MODIFICATION REQUEST:

***Dr Chau Chak Wing Building, University
of Technology Sydney, 14-28 Ultimo
Road, Ultimo
MP09_0153 MOD 4***

Modifications to condition B4 Mechanical
Ventilation and condition E9 Installation of
Rainwater Tanks

Secretary's Environmental Assessment Report
Section 75W of the *Environmental Planning and
Assessment Act 1979*

Figure 4: Roof Plan

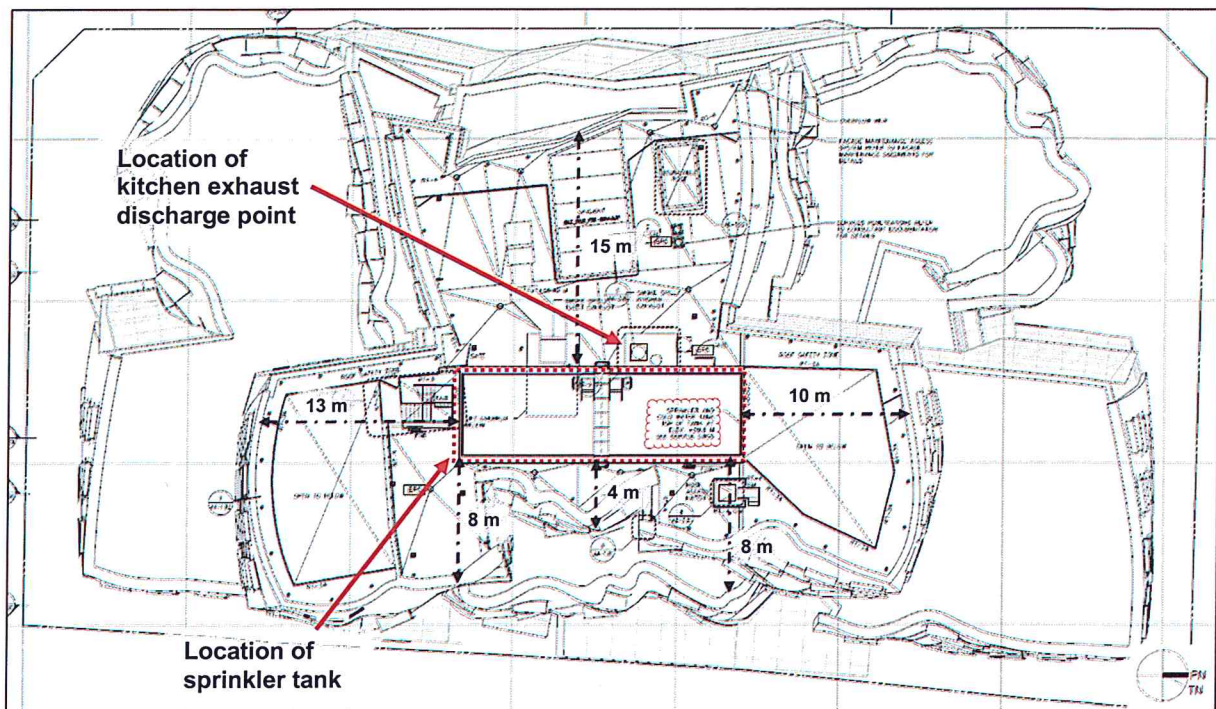
The proponent seeks prospective approval to increase the maximum building height of the approved development from 59.3 m to 59.6 m, or more specifically for the as-built height of the sprinkler tank 300 mm above the approved height under MOD 3. The increased height was discovered following a post construction survey of works completed, where it was found the finished height of the sprinkler tank was 59.6 m.

Figures 4 and 5 detail the central location of the sprinkler tank on the roof level of the approved building. The sprinkler tank is setback a minimum of eight metres from the building's eastern façade (approximate setback distances detailed in **Figure 4**).

The centralised location of the sprinkler tank combined with its setback from the building's façades ensures that the structure is not visible from the surrounding public domain. This is demonstrated in **Figures 2 and 3**, showing that the rooftop plant and equipment (i.e. the sprinkler tank) are not visible from the surrounding public domain. In this respect, it can be concluded that the additional 300 mm has a negligible visual impact and no effect on the bulk and scale of the approved building.
